MITIGATION PLAN

CARPENTER BOTTOM MITIGATION SITE

Re: NCIRT Review and USACE Approval of the NCDMS Carpenter Bottom Mitigation Site /
Buncombe Co./ SAW-2018-02062/ NCDMS Project # 100090

SUBJECT: Carpenter Bottom Mitigation Project - NCIRT Comments during 30-day Mitigation Plan Review

Figure 3 Site Map
 Carpenter Bottom Mitigation Site
 Catawba River Basin 03050102
 (03050103 Expanded Service Area)
 Gaston County, NC

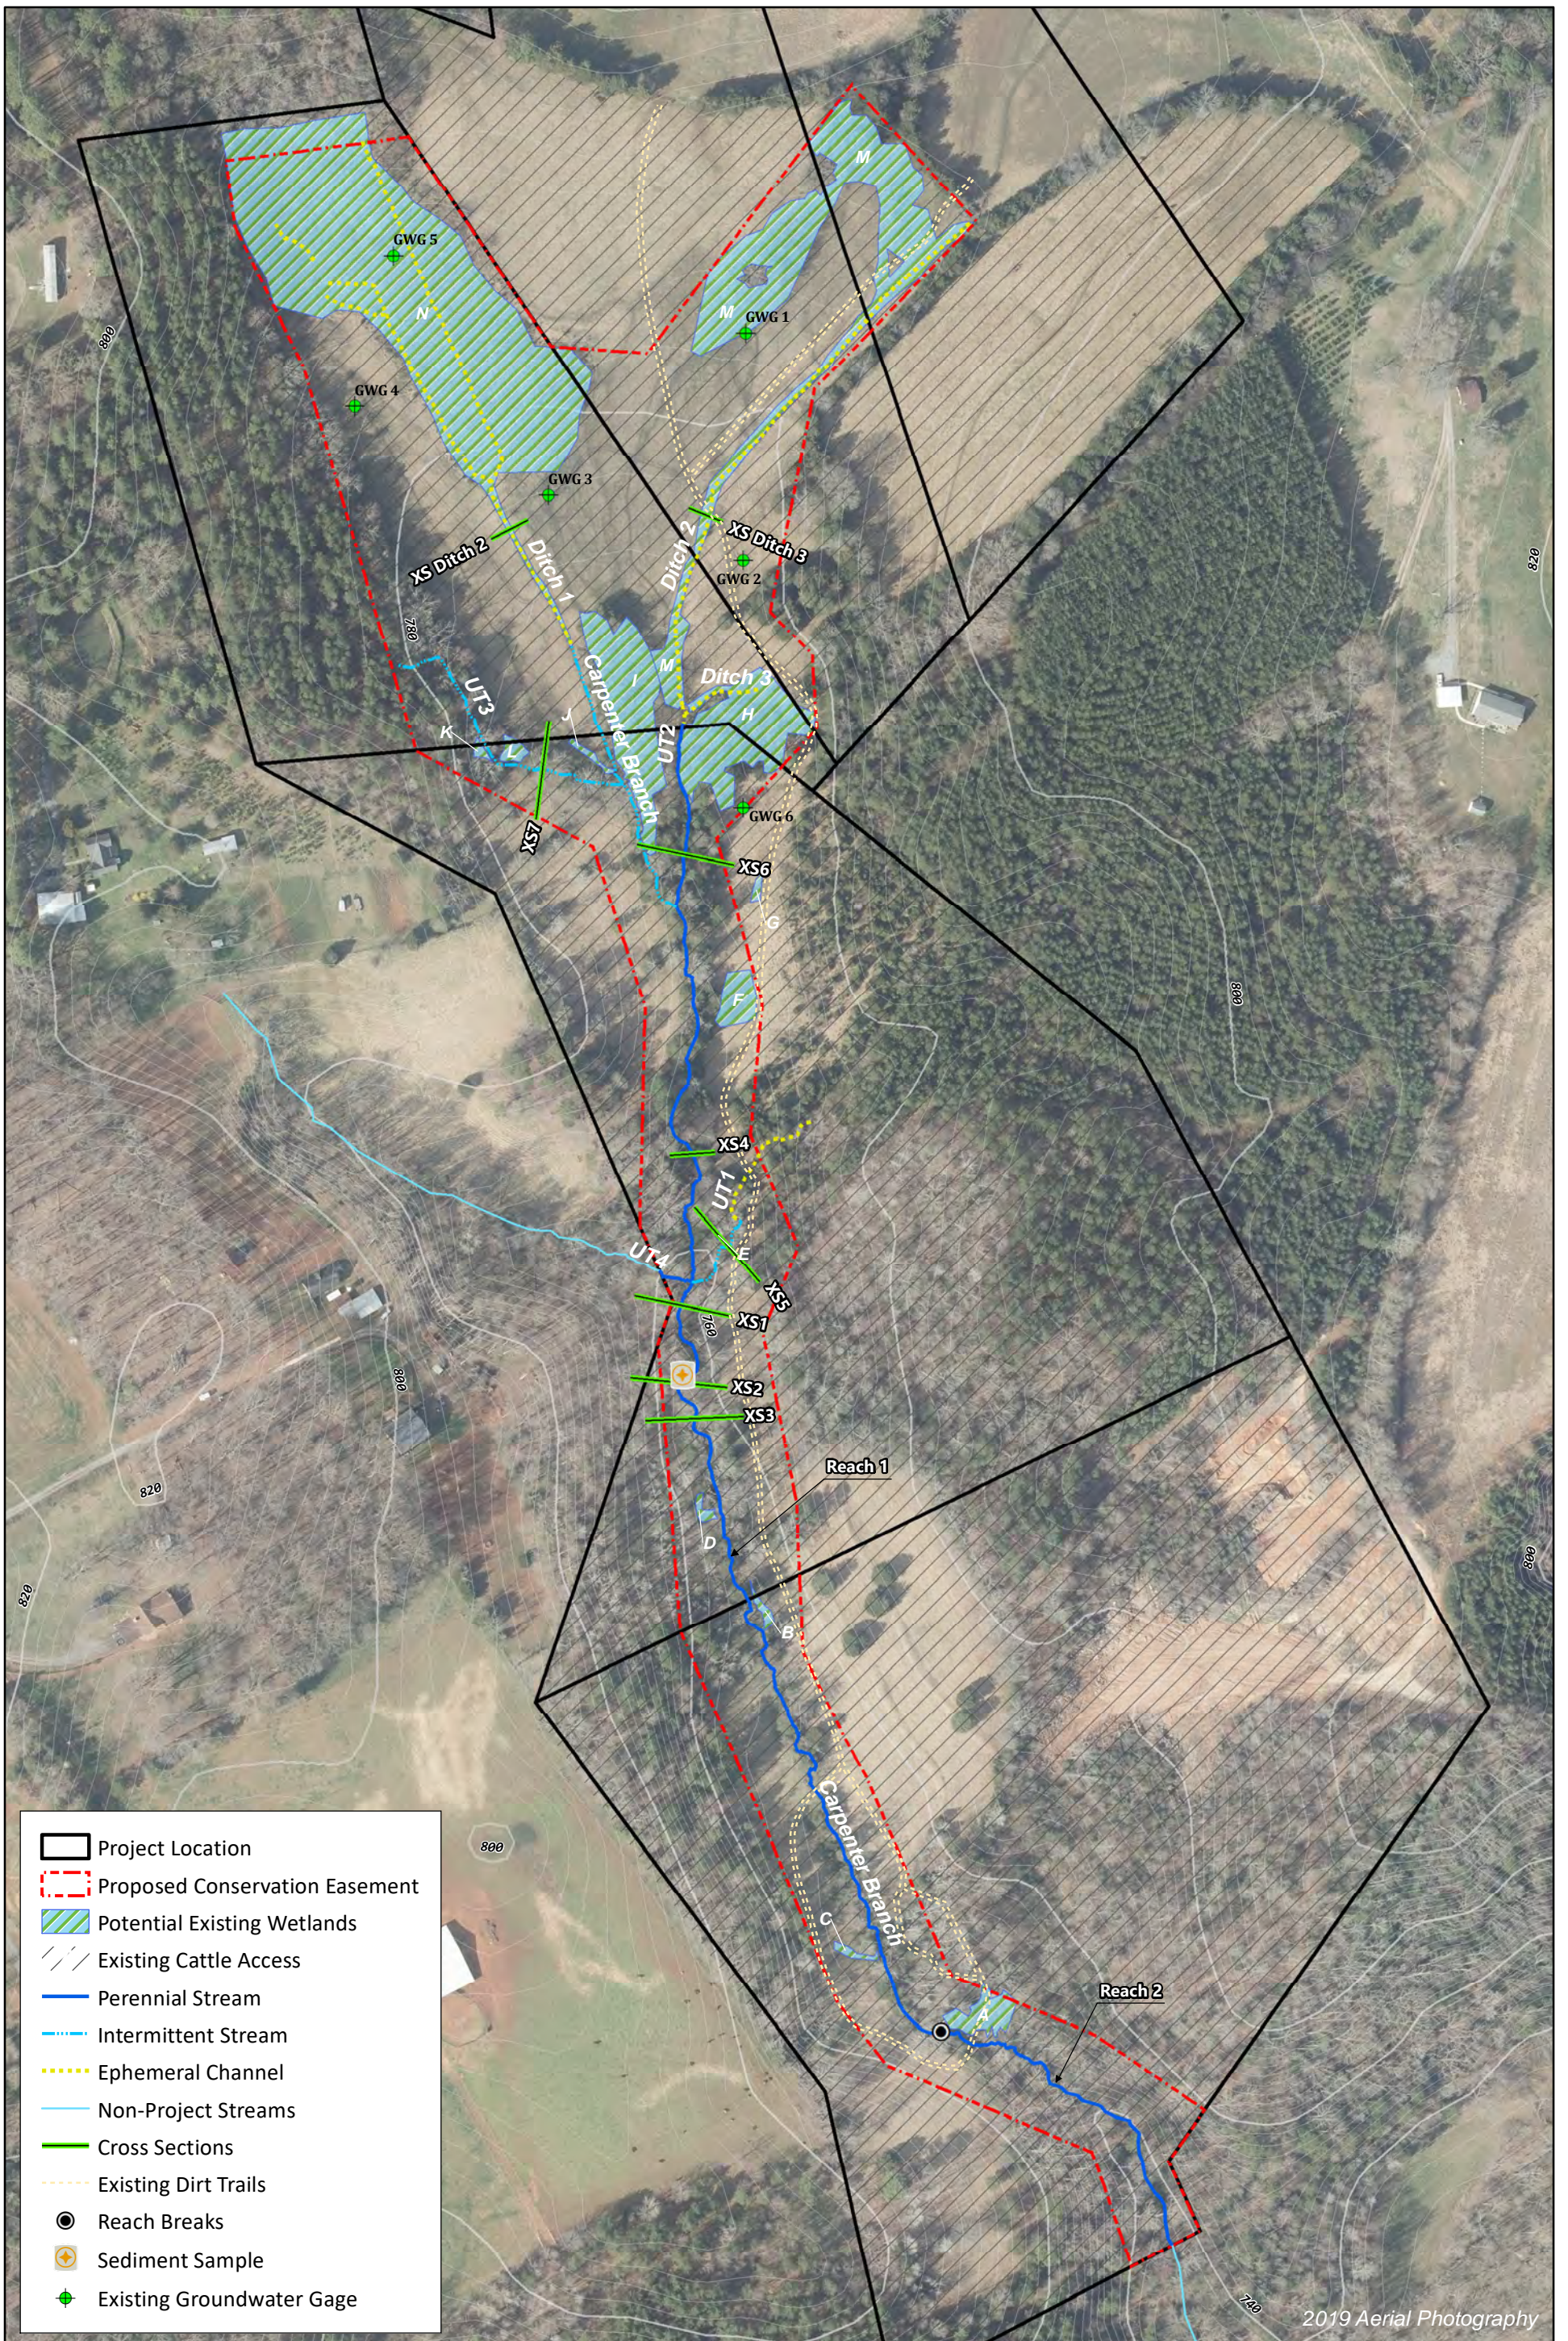
4. *It would be helpful to show the existing farm roads on Figure 3 since these areas will be a concern due to compaction. Please put at least one mobile veg plot in one of these areas.*

Wildlands Response: The existing farm roads are dirt trails which are currently used primarily for ATV and foot traffic. They will be decommissioned during construction by ripping as deemed necessary in the field to reduce soil compaction. The existing farm roads have been added to Figure 3. A mobile vegetation plot was added to Figure 10 in the location of one of the existing farm roads.
